REPORT TO THE
NUCLEAR REGULATORY COMMISSION

THE PACIFIC GAS AND ELECTRIC COMPANY

NUREG-0578:

"TMI-2 LESSONS LEARNED TASK FORCE
STATUS REPORT AND
SHORT-TERM RECOMMENDATIONS"

PRESSURIZER HEATERS
SINGLE LINE DIAGRAM
FIG. 2.1.1 - 1

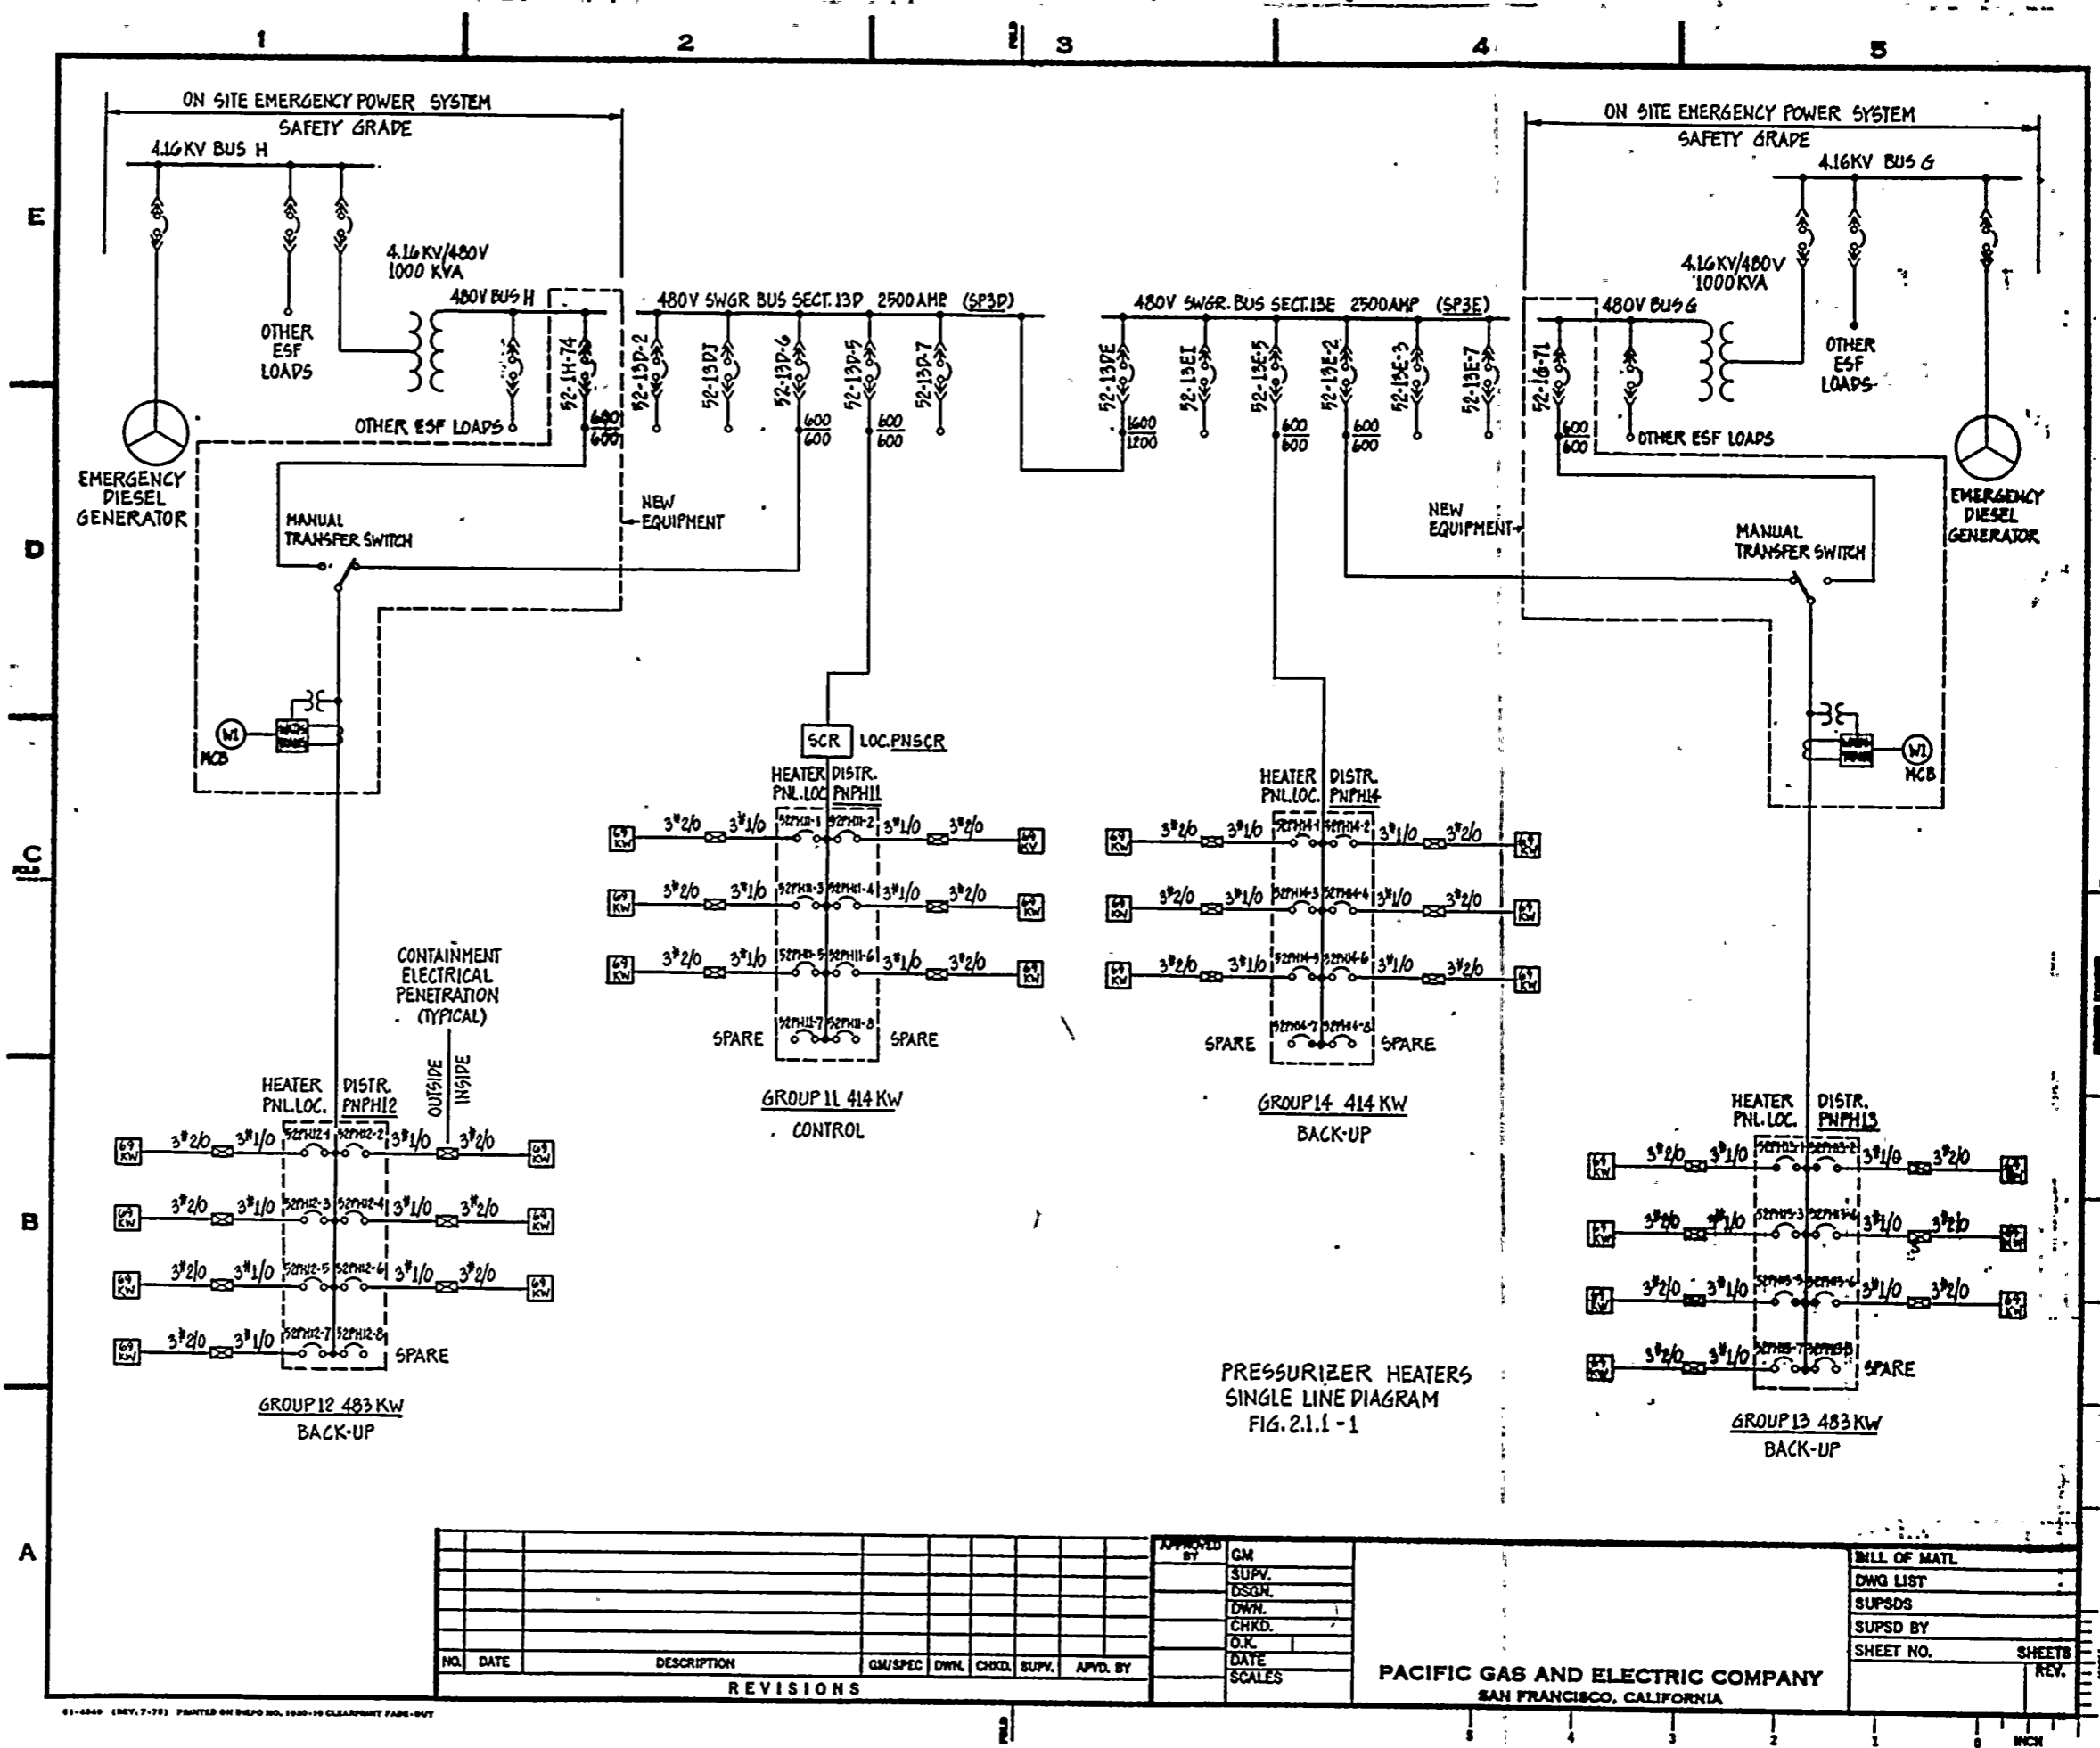
The pressurizer heater power supply design shall provide the capability to supply, from either the offsite power source or the emergency power source (when offsite power is not available), a predetermined number of pressurizer heaters, and associated controls necessary to establish and maintain natural circulation at hot standby conditions. The required heaters and their controls shall be connected to the emergency buses in a manner that will provide redundant power supply capability. (Category A: Implementation shall be completed prior to OL, or January 1, 1980, whichever is later.)

Power can be supplied to two of the four pressurizer heater groups from the offsite power source when available, or from the onsite emergency generators through the Engineered Safety Features (ESF) buses. Sufficient power is available from the ESF buses to energize enough heaters to establish and maintain natural circulation at hot standby conditions. Redundancy is provided by supplying each group of heaters from a different bus (see Figure 2.1.1-1).

Circuit breakers 52-1G-71 and 52-1H-74 will be added to 480 volt ESF buses 1G and 1H, respectively. These breakers will be seismically qualified and installed to meet safety-grade requirements.

Emergency power is generated by the onsite emergency diesel generators and supplied directly to the 4.16kV ESF buses. Power is then fed through a step-down transformer to the 480 volt ESF buses as shown on Figure 2.1.1-1.

FIGURE 2.1.1-8
PRESSURIZER LEVEL, #1
PRESSURE SET #4

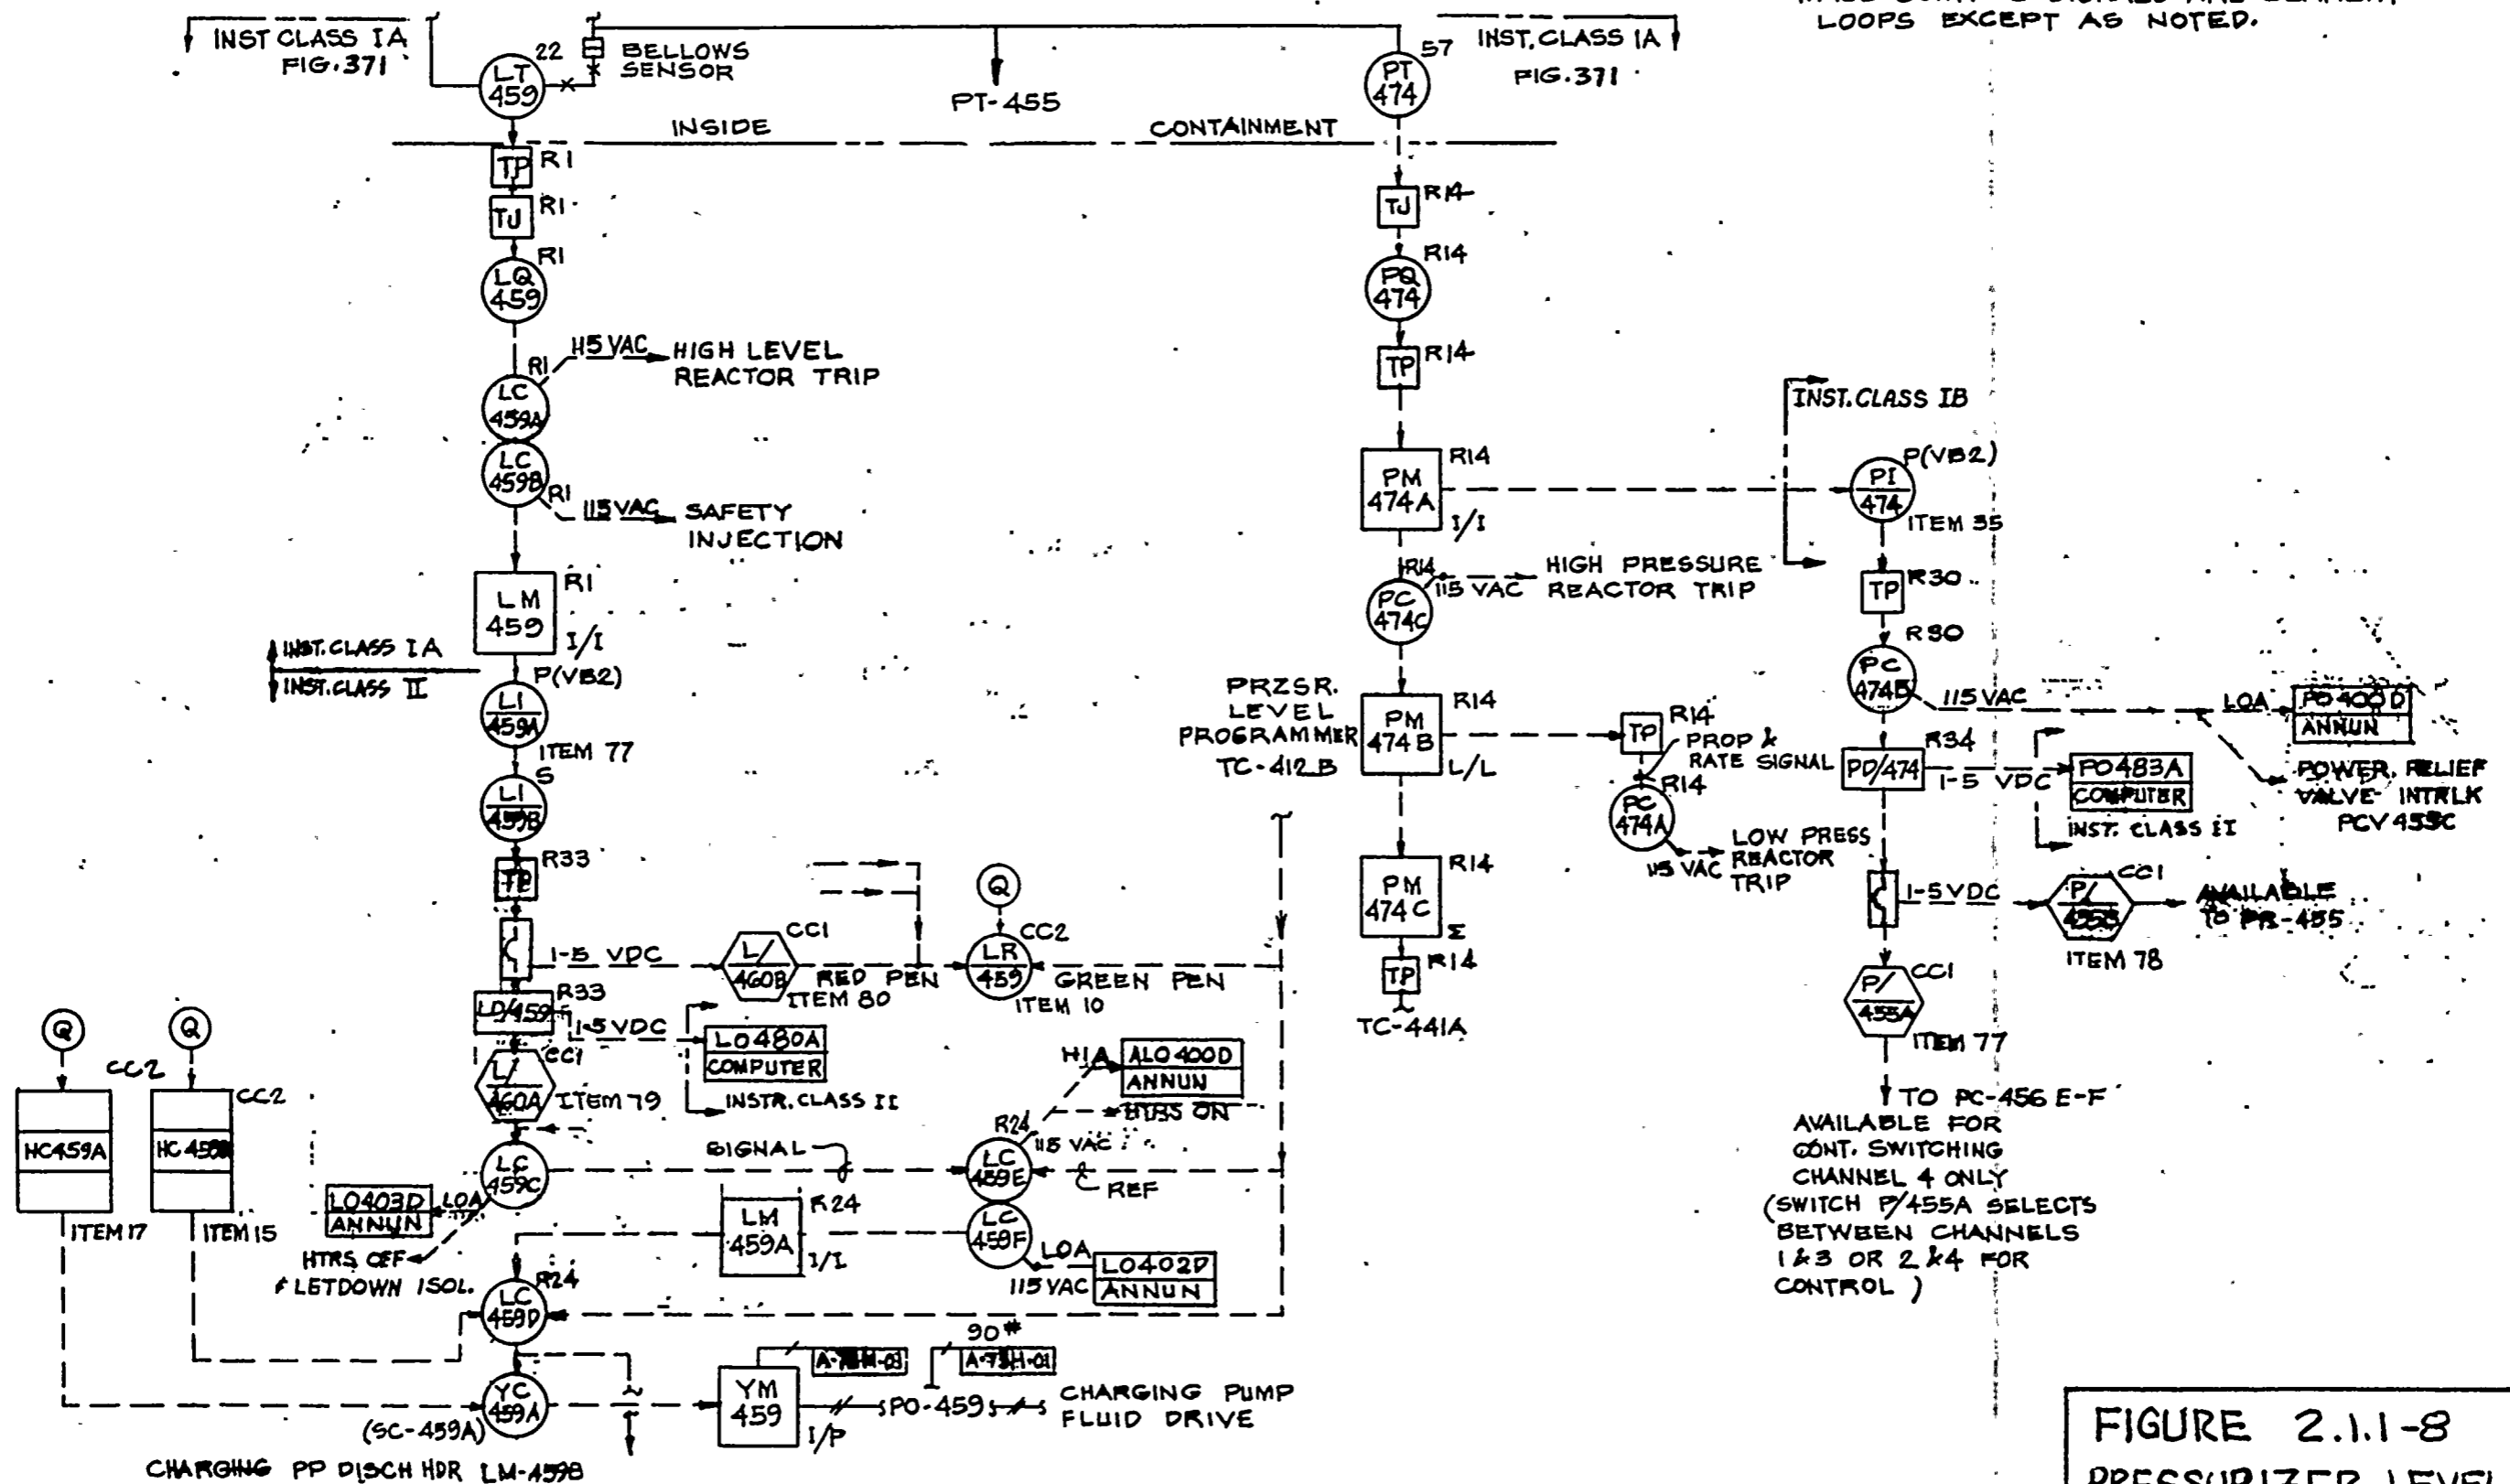
The pressurizer level indication instrument channels shall be powered from the vital instrument buses. These buses shall have the capability of being supplied from either the offsite power source or the emergency power source when offsite power is not available. (Category A: Implementation shall be completed prior to OL, or January 1, 1980, whichever is later.)

The pressurizer level indication circuits are safety-grade and post-accident qualified. AC power for all Class IE instrument channels is supplied from inverters which are supplied from the ESF buses with automatic backup from the emergency batteries (see Figures 2.1.1-4, 2.1.1-8 to 2.1.1-10).
